8. Well Name and No.  
JICARILLA 460-15 49. API Well No.  
30-039-2590410. Field and Pool, or Exploratory  
E. BLANCO/PICTURED CLIFFS11. County or Parish, and State  
RIO ARRIBA COUNTY, NM**SUBMIT IN TRIPLICATE - Other instructions on reverse side.**

## WELL LOCATION AND ACREAGE DEDICATION PLAT

**DRILLING PROGRAM**  
(Per Rule 320)

RE: Sundry Notice – **Horizontal Re-entry – Replacement Pages**  
Mallon Oil Company  
**CONFIDENTIAL**  
**Jicarilla 460-15 #4**  
**API #30-039-25904**  
**Surface:** 180' FSL 330' FEL (SE/4 SE/4) Unit P  
**End of Horizontal Hole:** 1,980' FSL 660' FWL (NW/4 SW/4)  
Sec. 15 T30N R3W  
Rio Arriba County, New Mexico  
Lease: Contract 460

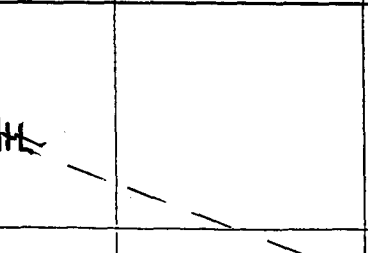
The original SN submitted to WIS on March 5, 2004 inadvertently contained the incorrect footage for the end of horizontal hole. The footage has been revised

From: 980' FSL 660' FWL (SW/4 SW/4)  
To: 1,980' FSL 660' FWL (NW/4 SW/4)

UL or lot no.	Section	Township	Range	Lot Idn	Feet from the	North/South line	Feet from the	East/West line	County
	15	30 N	3 W		1,980	South	660	West	Rio Arriba
